# CITY OF ALBUQUERQUE

Re: **New Mexico Expansion**  
**4401 Alexander Blvd. NE**  
**Traffic Circulation Layout**  
Engineer's/Architect's Stamp XX-XX-XX (F16-D003B1)

Based upon the information provided in your submittal received 09-26-22, the above referenced plan cannot be approved for Building Permit until the following comments are addressed:

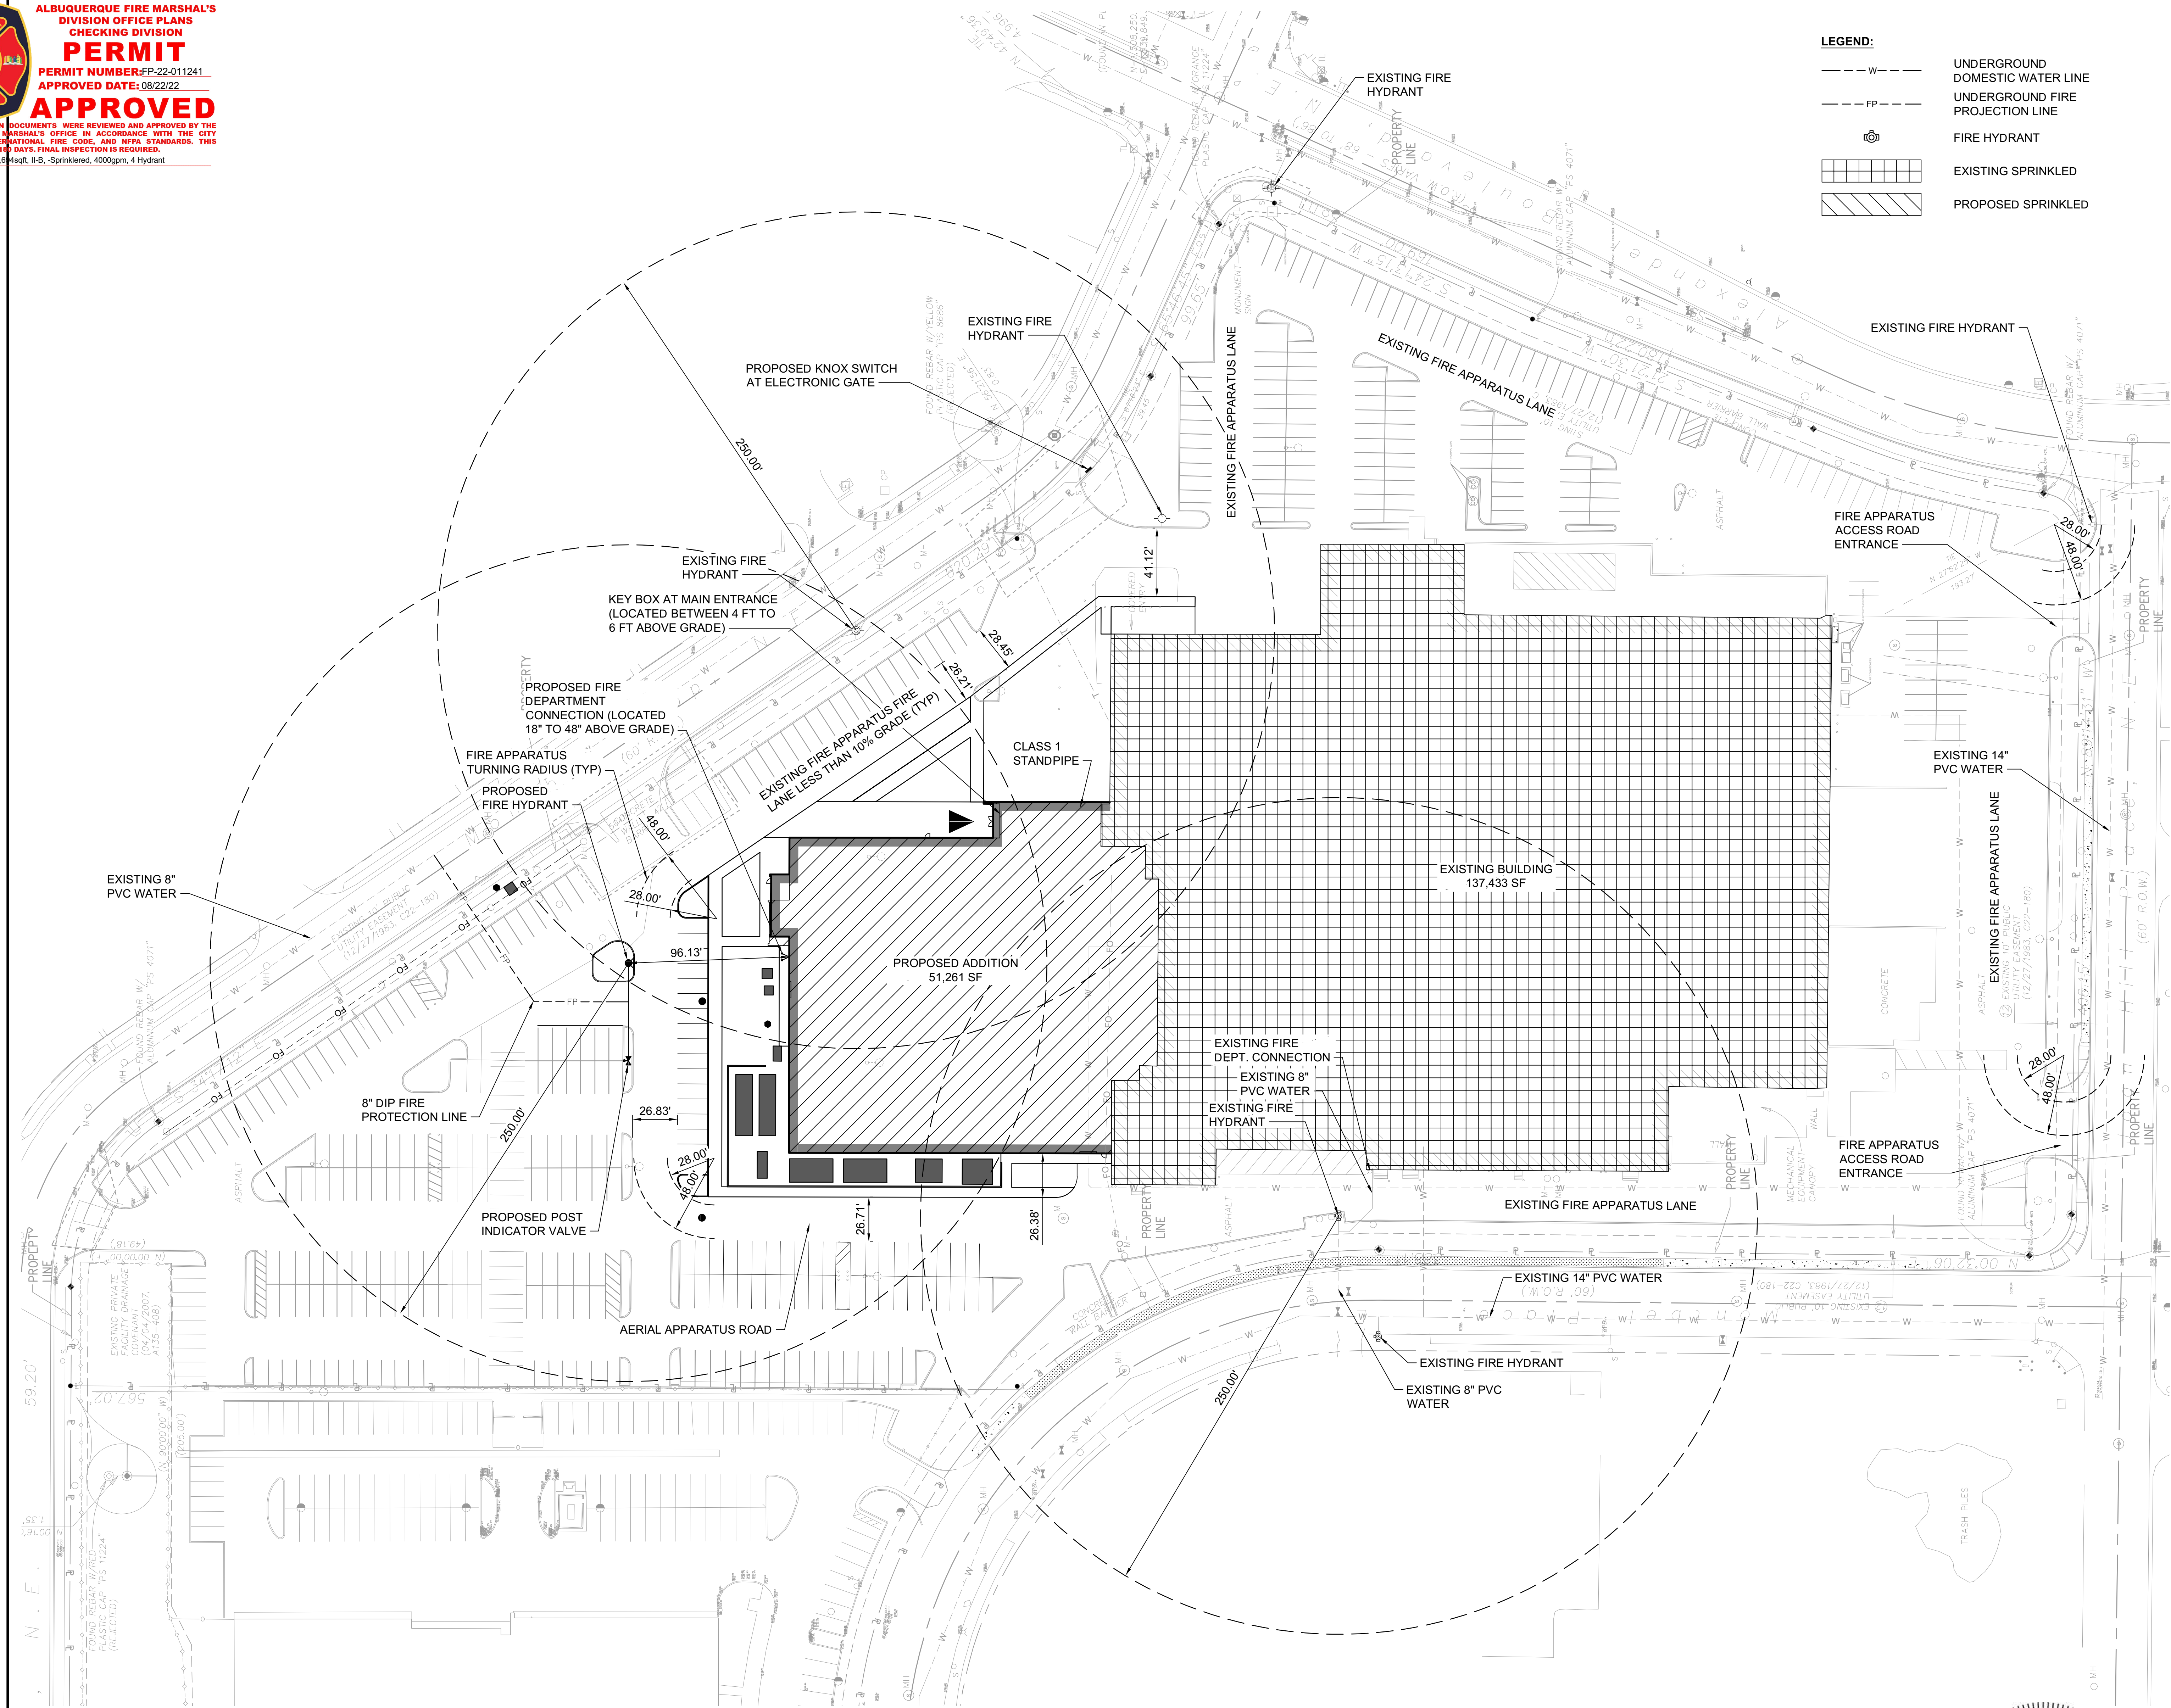
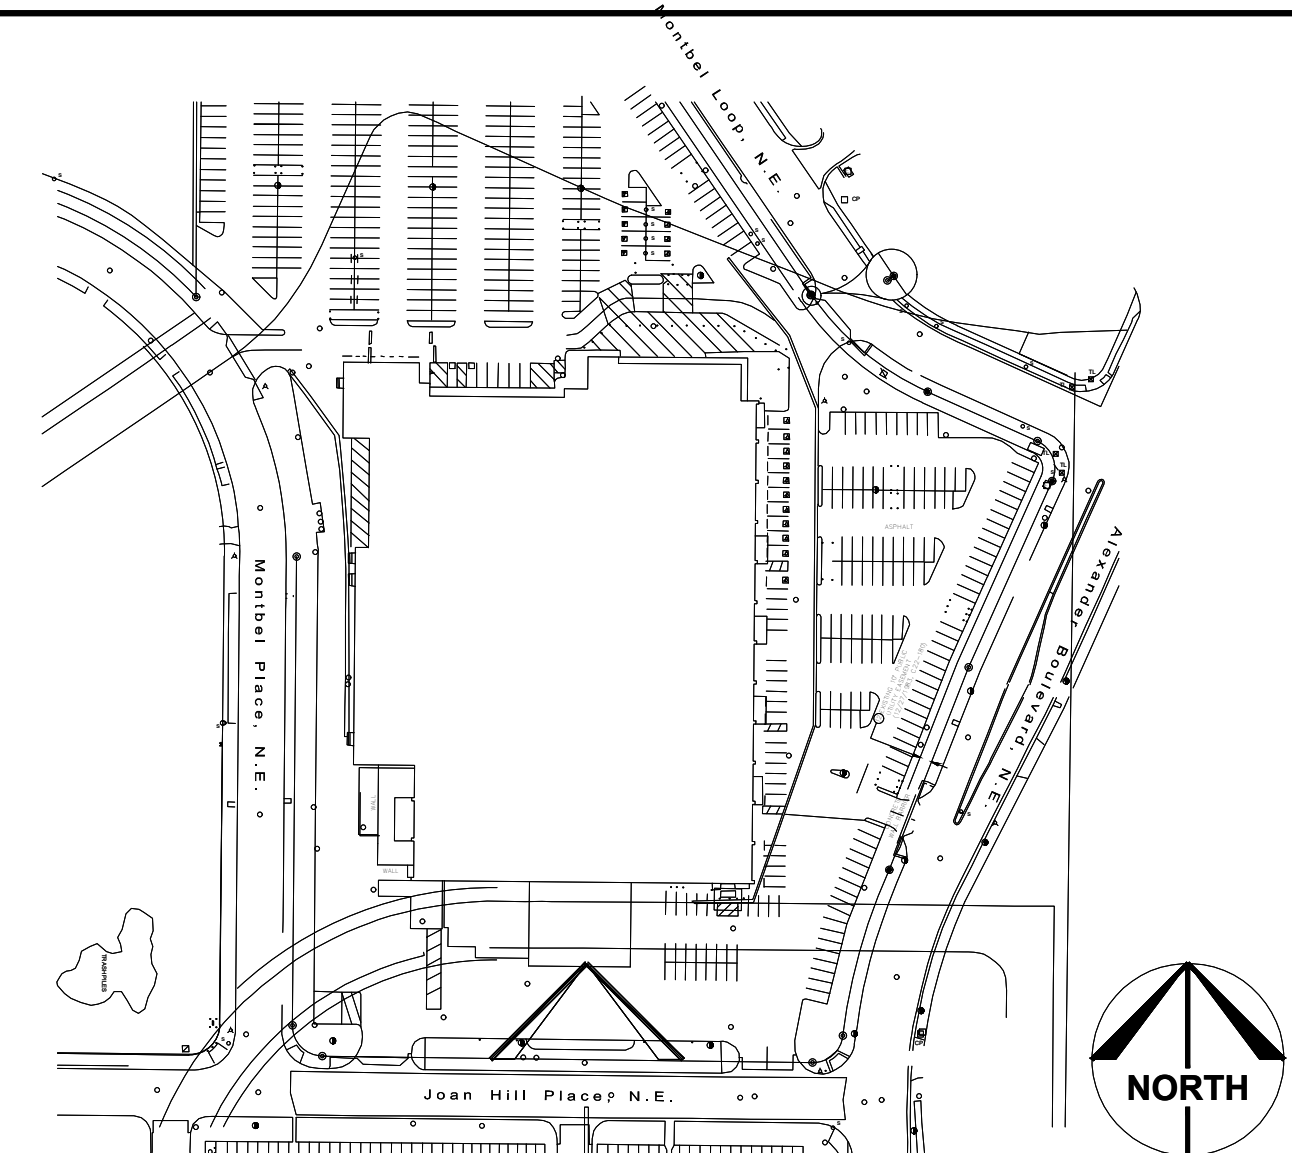
1. List the number of Motorcycle and Bicycle parking spaces required by the IDO.
2. The traffic circulation layout must be stamped, signed, and dated by an engineer or architect licensed in the state of New Mexico.
3. Clarify existing property lines and proposed property lines.
4. Sidewalk need to be built at the perimeter of the site, and reference COA std dwg 2430.
5. All sidewalks along streets should be placed at the property line.
6. Due to proposing gates, please provide turning templates.
7. Please list the width and length for all existing and proposed parking spaces. Some dimensions are not shown.
8. The minimum parking stall dimensions are:

Type of parking	Min. Width	Min. Length	Min. Overhang
Standard	8.5'	18'	2'
Compact	7.5'	15'	1.5'
Motorcycle	4'	8'	N/A
ADA	8.5'	18'	2'

9. The ADA accessible parking sign must have the required language per 66-7-352.4C NMSA 1978 **"Violators Are Subject to a Fine and/or Towing."** Please call out detail and location of signs.
10. ADA curb ramps must be updated to current standards and have truncated domes installed.
11. Motorcycle parking spaces shall be designated by its own conspicuously posted upright sign, either free-standing or wall mounted per the zoning code.

12. The pavement marking "MC" should be shown in the opposite direction for motorcycles entering the parking space.
13. All bicycle racks shall be designed according to the following guidelines:

- a. The rack shall be a minimum 30 inches tall and 18 inches wide.
  - b. The bicycle frame shall be supported horizontally at two or more places. Comb/toaster racks are not allowed.

- c. The rack shall be designed to support the bicycle in an upright position. See the IDO for additional information.
  - d. The rack allows varying bicycle frame sizes and styles to be attached.

- e. The user is not required to lift the bicycle onto the bicycle rack.
  - f. Each bicycle parking space is accessible without moving another bicycle.

14. Bicycle racks shall be sturdy and anchored to a concrete pad.
15. A 1-foot clear zone around the bicycle parking stall shall be provided.
16. Bicycle parking spaces shall be at least 6 feet long and 2 feet wide.

17. Please provide details for all the proposed signs and pavement marking.
18. Per the IDO, a 6 ft. wide ADA accessible pedestrian pathway is required from the public sidewalk to the building entrances. Please clearly show this pathway and provide details.

19. Per DPM, a 6 ft. wide ADA accessible pedestrian pathway is required from the ADA parking stall access aisles to the building entrances. Please clearly show this pathway and provide details.

20. ADA accessible pedestrian pathway should not be placed behind parking space or adjacent to a vehicular way. Vehicle and pedestrian/wheel chair conflicts should be avoided as much as possible.

21. Define ADA pathways by labeling of ramps, flush pavement, dimensioning of pathways, doorways, etc.
22. Curbing should be installed to delineate landscape, parking, and pedestrian ways and identify points of access. Please call out detail and location of barrier curb.

23. Parking areas shall have barriers to prevent vehicles from extending over public sidewalk, public right-of-way, or abutting lots.
24. Refuse vehicle maneuvering shall be contained on-site. The refuse vehicle shall not back into the public right of way. provide a copy of refuse approval.

25. It is not apparent what type of pavement surface is being proposed. A hard driving surface will be required as part of this proposed project for parking area and drive aisles.

26. Please provide a sight distance exhibit
27. Show the clear sight triangle and add the following note to the plan: "Landscaping and signage will not interfere with clear sight requirements. Therefore, signs, walls, trees,

and shrubbery between 3 and 8 feet tall (as measured from the gutter pan) will not be acceptable in the clear sight triangle.

28. Please specify the City Standard Drawing Number when applicable.
29. Provide notes showing what work is included and on the work order and the private work on site.
30. Work within the public right of way requires a work order with DRC approved plans.
31. Please add a note on the plan stating "All improvements located in the Right of Way must be included on the work order."
32. Please provide a letter of response for all comments given.
33. Traffic Studies: See the Traffic Impact Study (TIS) thresholds. In general, a minimum combination of 100 vehicles entering and exiting in the peak hour warrants a Traffic Impact Study. Visit with Traffic Engineer for determination, and fill out a TIS Form that states whether one is warranted. In some cases, a trip generation may be requested for determination (**Contact Matt Grush: [mgrush@cabq.gov](mailto:mgrush@cabq.gov)**).
